TABLE OF CONTENTS

A. Statement of Technical Rationale and Justification

B. Text of Regulations

Figure 1 : Illustration of Ambient Altitude and Temperature Conditions

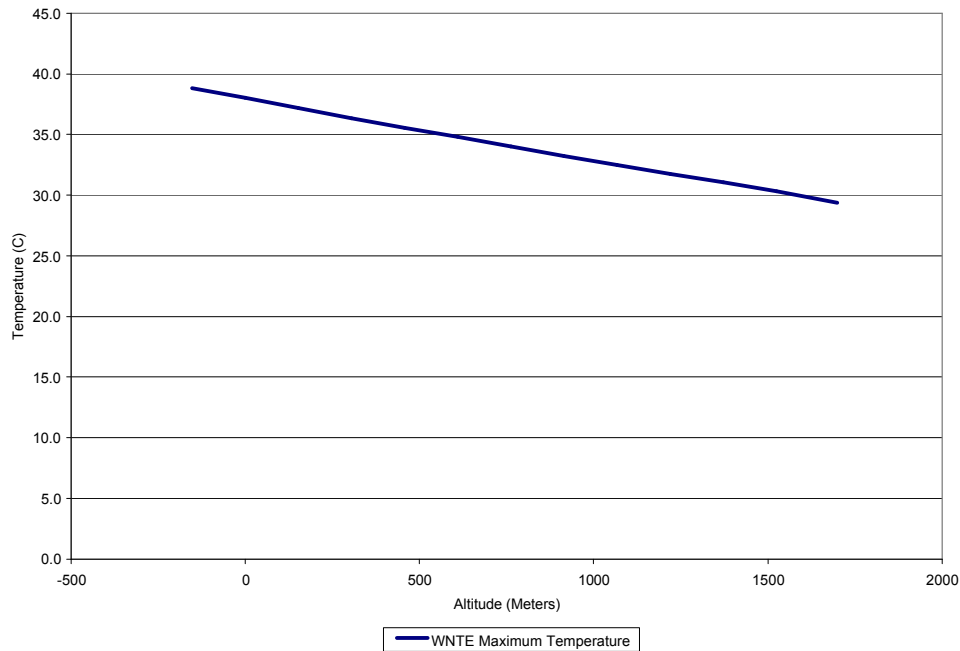
[Comment: Figure 1 should be updated to label x-axis as "Atmospheric Pressure" with units in kPa]

Figure 2: Example WNTE Control Area

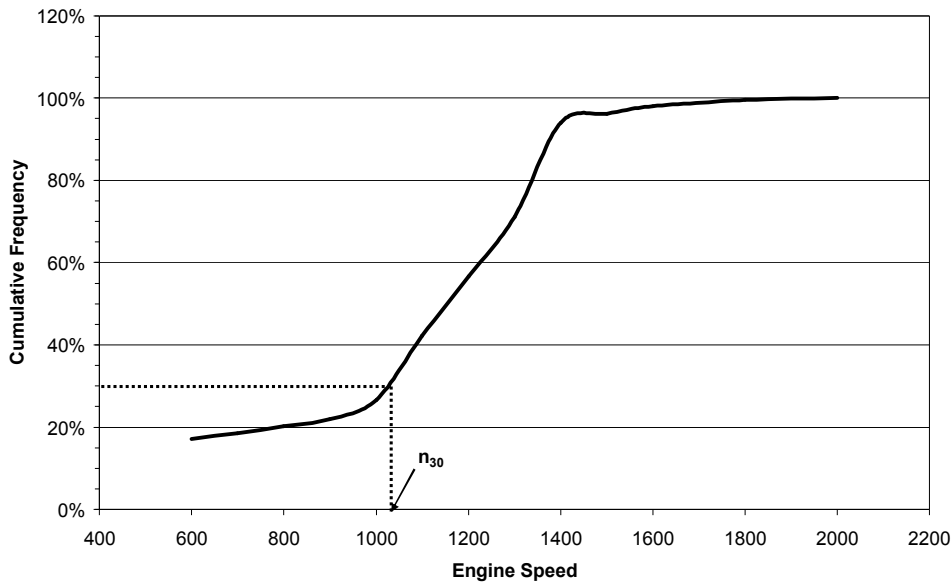
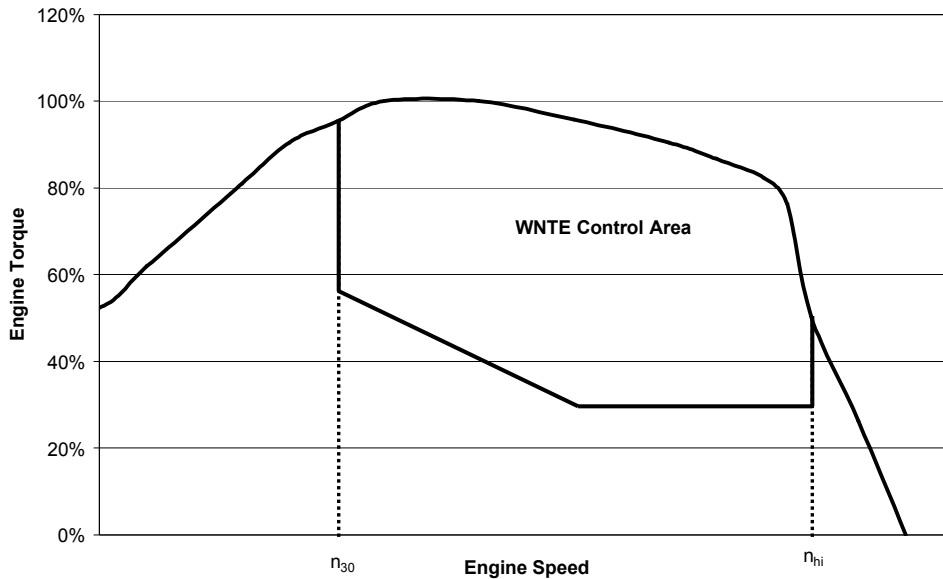
Editorial Comment: Update figure 2 and 3 to correspond with final control area established in gtr.

[Comment : Figures 2 and 3 are out of sequence]

Figure 5: WNTE test cycle grids [new figure to be provided by EC]

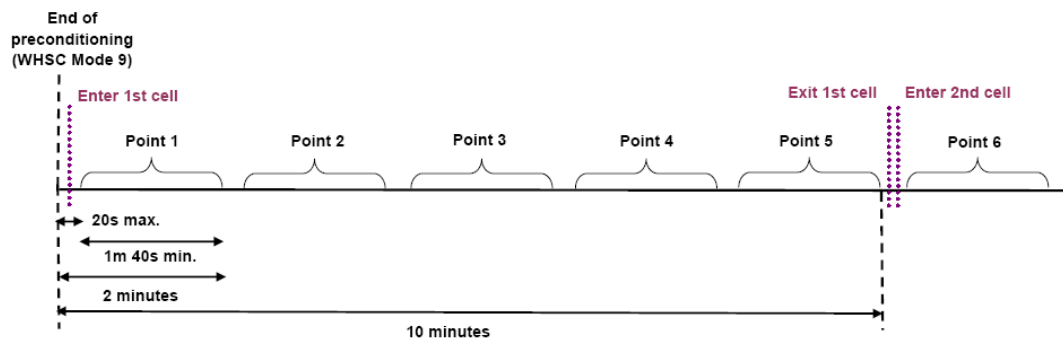
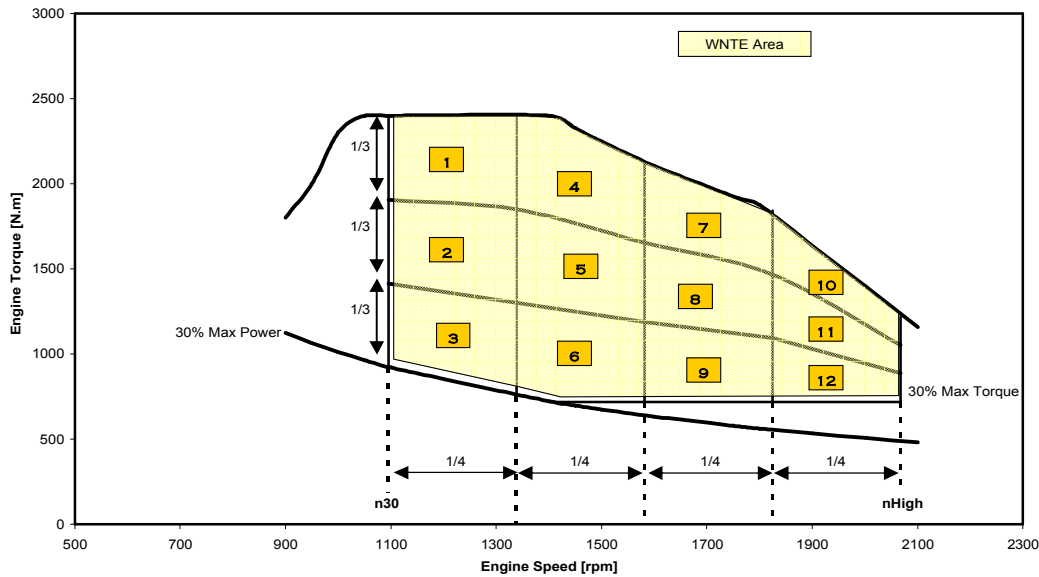
[Comment: Figures 4 and 5 are out of logical sequence]
